OSART

CRUAS

NUCLEAR POWER PLANT

**DIVISION OF NUCLEAR INSTALLATION SAFETY
OPERATIONAL SAFETY REVIEW MISSION
IAEA-NSNI/OSART/08/148F**

The diagram below (based on assessments by corporate level) shows the trend in the NPP's condition:

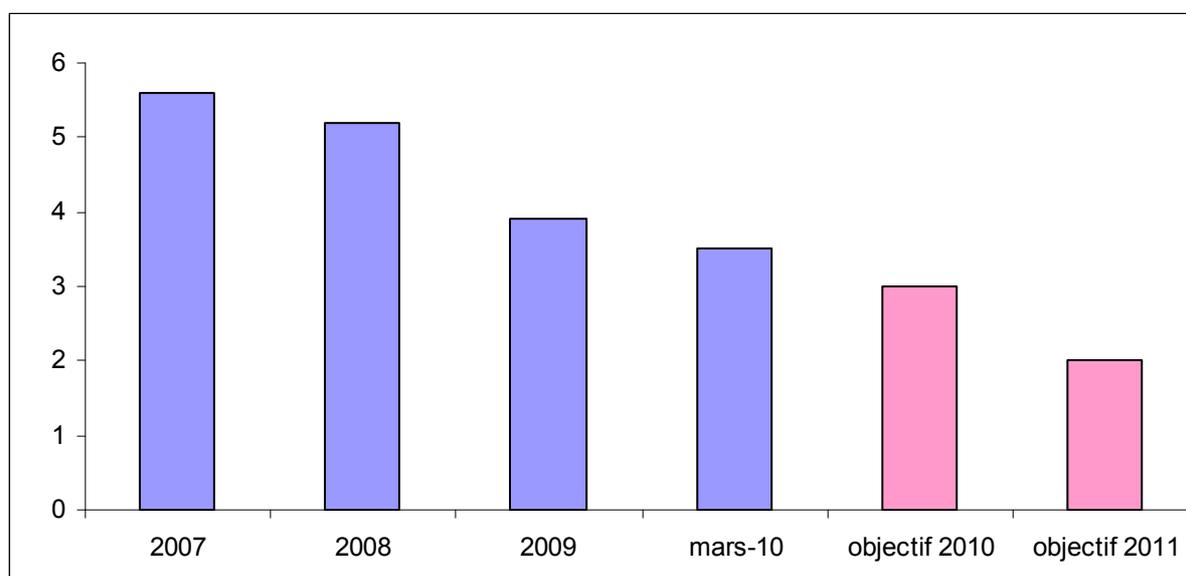
Substantial progress with respect to equipment and plant condition has been achieved:

Over a period of 4 years, more than €33m will have been spent, to renovate civil engineering and equipment, buy materials to protect floors and collect leaks, improve lighting, labelling and cleaning and make modifications on equipment with recurrent leaks. Investment will continue in 2011.

To measure the effectiveness of its action plans, the plant is regularly assessed by experts from EDF corporate departments.
